Subject : MHI Muskrat Falls DG3 Review report (draft)

Review of the Muskrat Falls and Labrador Island HVdc Link and the Isolated Island Options

September 2012

DRAFT

Figure 9: Climatic Ice Loads along the HVdc Transmission Line Route compared to the CSA Standard 1:500-year return period limit

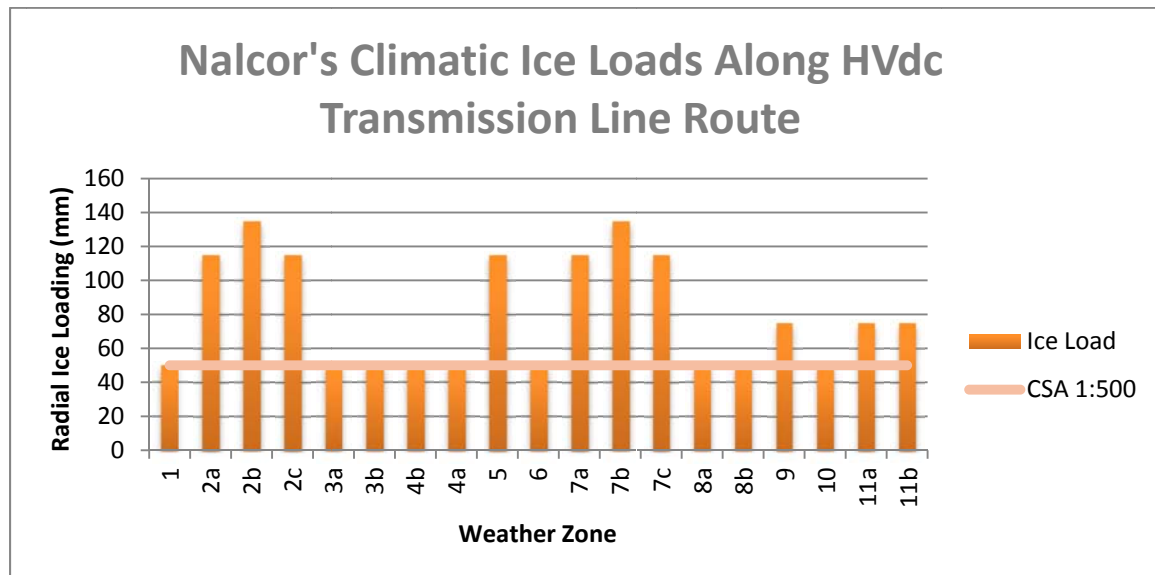
Nalcor's research studies to define the climatic loadings along the transmission line route were based on 50 years of data, as outlined in the document "Muskrat Falls Project – Exhibit 97, Appendix A Revision 1". The climatic loadings for each line section are approximately equivalent to the climatic loadings calculated assuming a Canadian Standards Association (CSA) 1:500-year return period.

MHI notes that CAN/CSA C22.3 suggests a greater reliability of design to 1:150-year or 1:500-year return periods for lines of voltages greater than 230 kV which are deemed of critical importance to the electrical system. It is MHI's opinion the ± 350 kVdc and 315 kV ac lines proposed for the Lower Churchill Project be classified in a critical importance category due to their operating voltage and role in Nalcor's long term strategic plan for its transmission system and be designed to a reliability return period greater than 1:50 years.
